## COAL MINING AND RECLAMATION PERMIT APPLICATION TO REVISE A PERMIT (ARP)

**Permit Number:** D-425  
**Application Number:** R-425-13

**ARP Type:**  
Add Sediment Pond

<b>APPLICANT</b>	American Energy Corporation	<b>ARP #</b>	R-425-13
<b>ARP SUMMARY</b>	Add Sediment Pond for Drainage Control		
<b>DISTRICT</b>	Cambridge	<b>APP. MANAGER</b>	Treva Knasel
<b>DATE RECEIVED BY APPLICATION MANAGER</b>		5-14-2003

As-Built Pond EBS-3  
Plan View

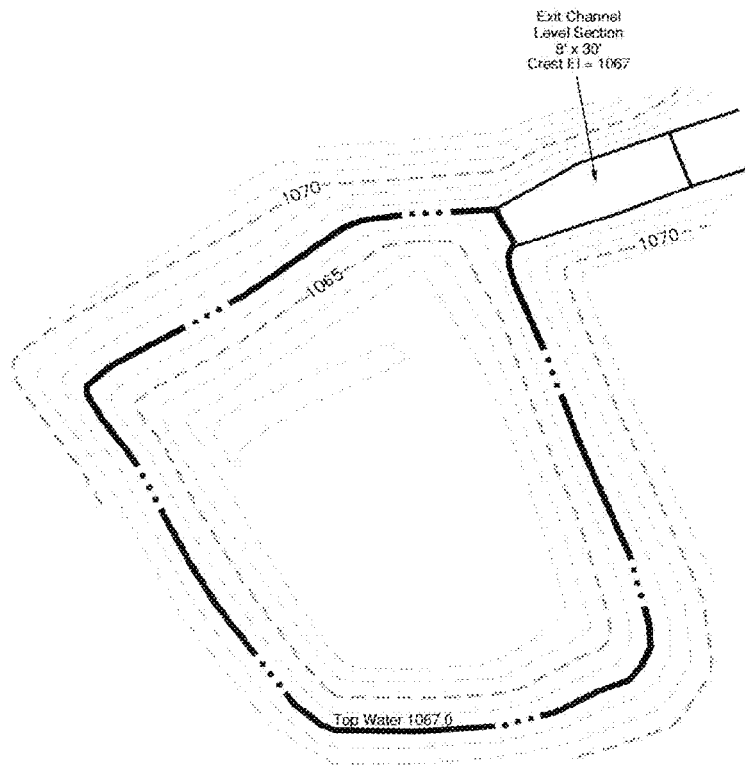
COMMENTS: MAP - SHOW DISTURBED AREA AND DIVERSIONS  
DIRECTING DRAINAGE TO POND EBS-3.

1. Show disturbed area and diversions directing drainage to Pond EBS-3 on map.

1. Revised to show the disturbed area and diversions directing drainage to Pond EBS-3 on the map as requested.
